# **Building Code of Australia**

## **Compliance Capability Statement**

**Project Address: Waterloo Metro Quarter Over Station  
Development, Building 1 & 2 Basements**

Report Number: 200497 Basements

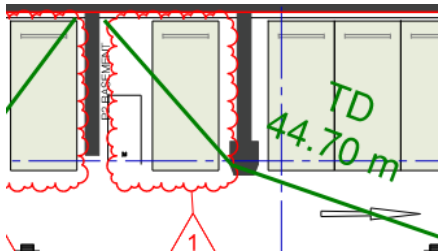
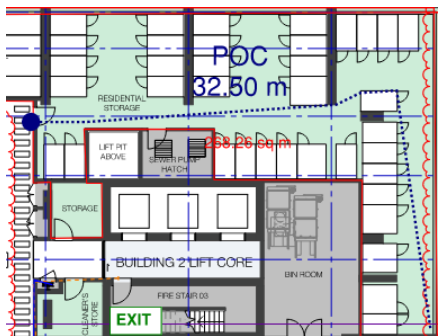
D1.4	Exit travel distances	<p>No point on the floor must be more than 20m from an exit, or a Point of Choice (POC) from which travel in different directions to 2 exits is available, in which case the maximum distance to one of those exits must not exceed 40m.</p> <p>Extended travel distance to exits and POC has been identified as follows: -</p> <p><b>Level P1</b></p> <ul style="list-style-type: none"> <li>▪ 50m to Exit - Central Car Spaces</li> </ul>  <ul style="list-style-type: none"> <li>▪ 24m to POC - Male EOT</li> </ul>	Performance Solution

- 24m to POC - Distributor Room

**Level P2**

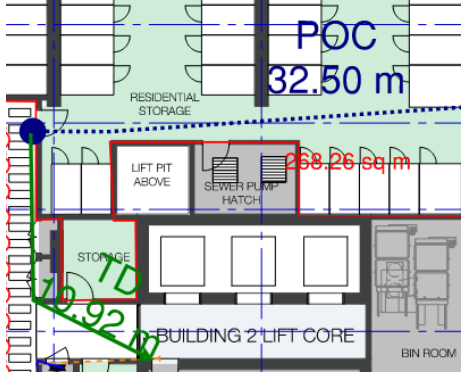
- 45m to Exit - Central Car spaces

- 33m to POC - Residential Storage

- 44m overall travel distance to Exit - Residential Storage
